Project B1909583

Re: Addendum 1 to Geotechnical Evaluation
Cherrywood Pointe
5501 American Boulevard West
Bloomington, Minnesota

This letter serves as Addendum 1 to our Geotechnical Evaluation Report for this project, dated June 21, 2019. This Addendum addresses stormwater management design.

Test Number:	DRI-2
Project Description:	Cherrywood Pointe - BL
Project Number:	B1909583
Date:	January 31, 2020
Liquid used:	Potable water
Inner Ring Area:	113 square inches
Outer Ring Area:	452 square inches
Water depth Inner Ring (in):	6
Water depth annular Ring (in):	6
Weather:	28°/Snow

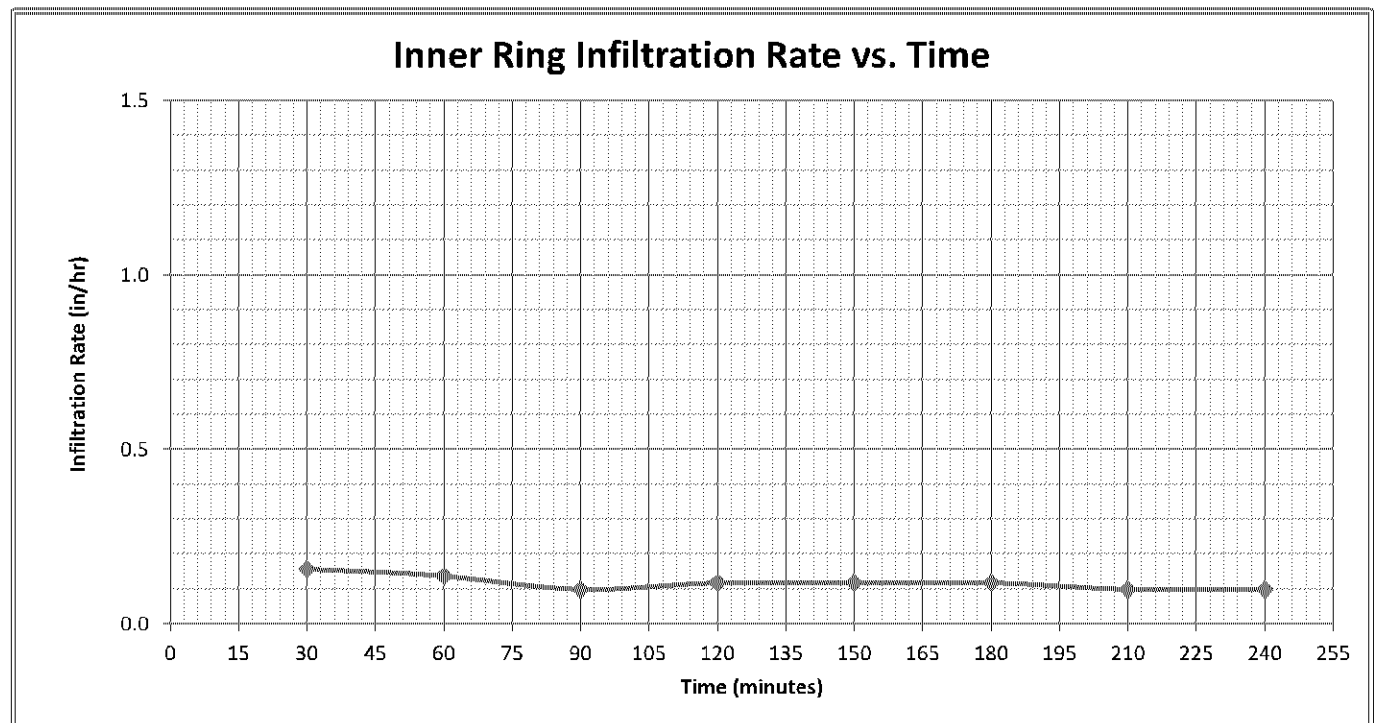
We conducted Double Ring Infiltrometer tests according to ASTM D 3385 in the Glacial Till soils on the south end of Underground Stormwater System 2A and north side of Infiltration Basin 2B. The results of the tests indicated an infiltration rate ranging from 0.11 to 0.32 inches per hour (in/hr).

A slightly higher infiltration rate was measured in Infiltration Basin 2B, which is anticipated to be influenced by the nearby presence of Glacial Outwash soils. As the Glacial Outwash soils were only encountered as pockets of material, it is anticipated that these pockets would fill with water in a rain event and then drain away at the rate at which the Glacial Till will drain. For this reason we recommend the design infiltration rate for this site be considered 0.11 in/hr. We recommend the soil be loosened to a depth of at least 3 feet below the invert elevation by tilling or ripping.
